COUNTY OF YOLO

Re: Comments on the Public Draft EIR/EIS for the Bay Delta Conservation Plan

Draft EIR/EIS for the Bay Delta Conservation Plan
 Comment Table—Yolo County
 July 29, 2014

Figure 1-2

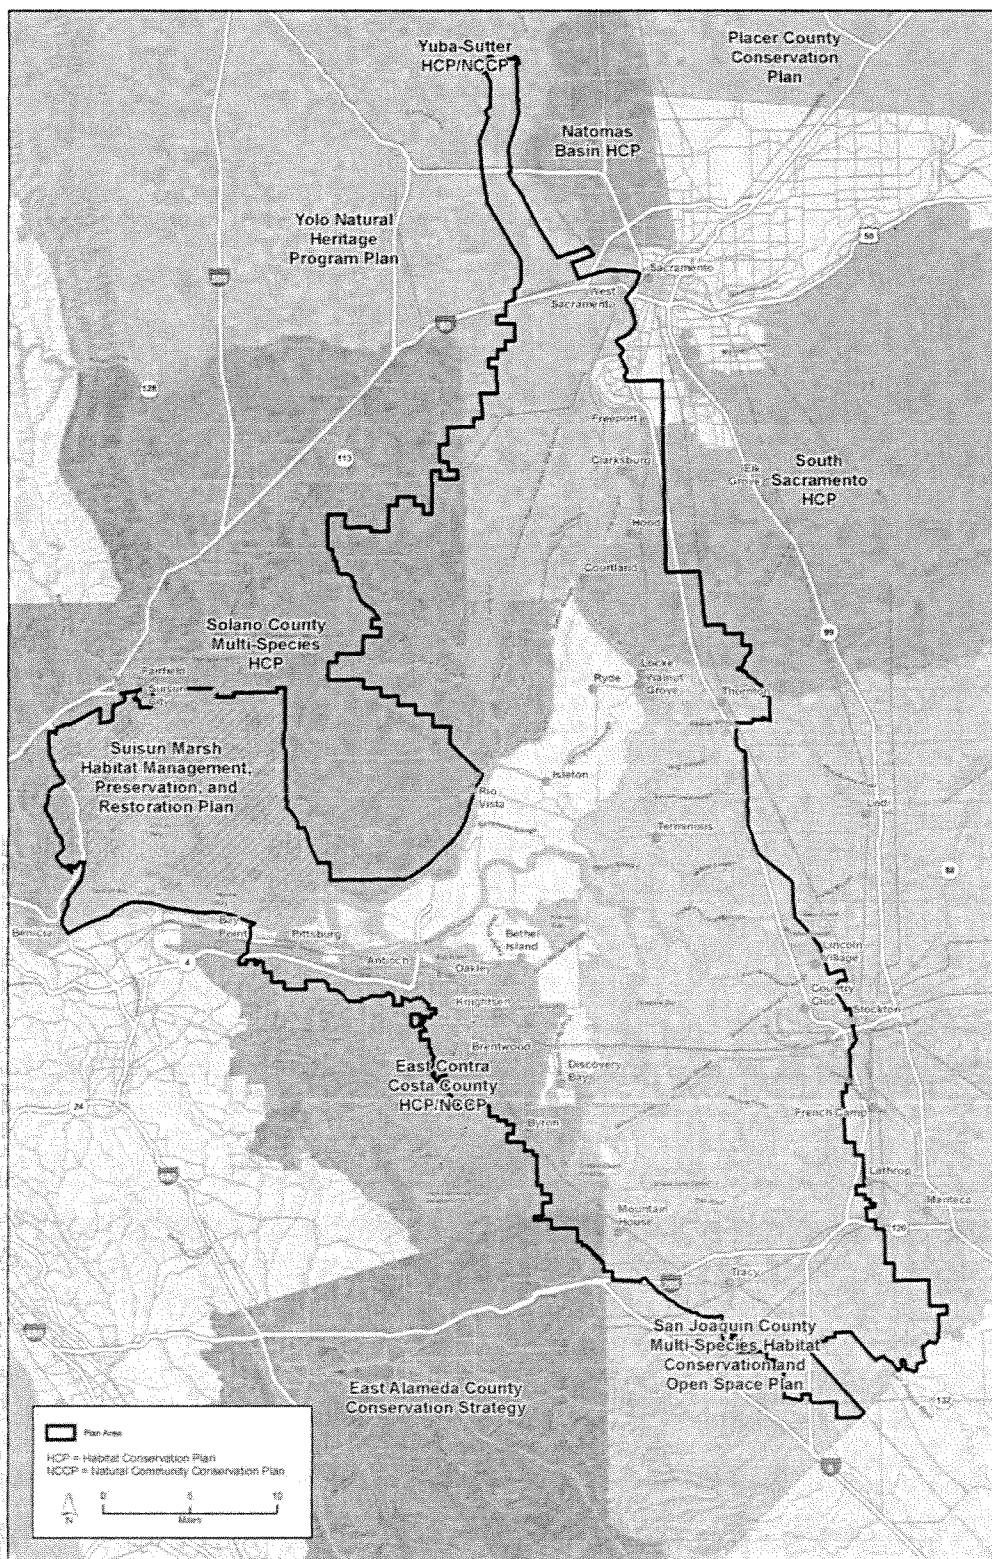
The Yolo Natural Heritage Program (Yolo HCP/NCCP) and Bay Delta Conservation Plan (BDCP) Plan Areas overlap (Figure 1-2 from 2013 BDCP draft). The Yolo HCP/NCCP encompasses the entirety of Yolo County, covering an area of 653,820 acres of which approximately 108,000 acres in Yolo HCP/NCCP Planning Units 15-18 and 21 overlap with the BDCP Plan Area (Figure 1). The BDCP encompasses the statutory Sacramento-San Joaquin Delta as defined in the California Water Code, Section 12220 and additional lands in the upper Yolo Bypass and Suisun Marsh necessary to implement the proposed BDCP conservation actions. In addition, the BDCP has adjusted its planning area to allow the BDCP to undertake conservation actions in Yolo County that could lead to additional overlap with the Yolo HCP/NCCP. The BDCP has expanded the BDCP Plan Area to allow for protection of approximately 1,400 acres of giant garter snake habitat in Planning Unit 11 adjacent to and west of the Yolo Bypass.
